SERVICE BULLETIN 73

SUBJECT: POSSIBLY INCORRECT ENGINE MOUNT NUTS

APPLICATION: All Glasair aircraft.

FIGURE (1)

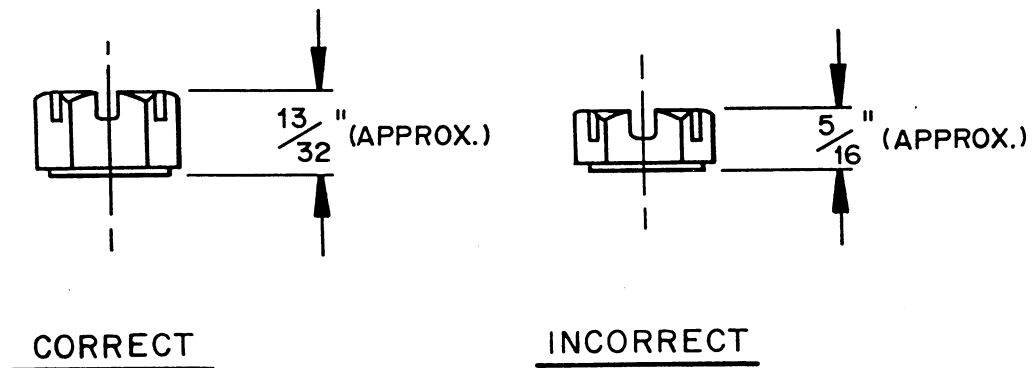
DESCRIPTION: Some of the nuts that we have stocked since about 1986 for the engine mount bolts are incorrect. The nuts specified for the engine mount bolts are AN355-6 nuts, which are a tension type nut (about 13/32" long) to carry the tension loads on the engine mount bolts. Instead of the AN355-6 nut, our supplier shipped us a nut that is only about 5/16" long. These incorrect nuts are not as thin as a shear nut (AN320-6, 7/32" thick) which may only be used when the only loads applied to the bolt are perpendicular to the longitudinal axis of the bolt. Since we are unable to identify the nuts per AN, MS, or NAS standards, however, we are unable to determine their rated tension loads.

SOLUTION: Measure the length of the nuts (labelled AN355-6) supplied for your engine mount bolts. If the nuts are less than 13/32" long, as shown in FIGURE (1), the nuts are incorrect and must be replaced.

If you have the incorrect nuts, notify Stoddard-Hamilton's shipping department and we will ship replacements. We are asking that you return the incorrect nuts first, as usual, so that we can return them to our supplier for credit.
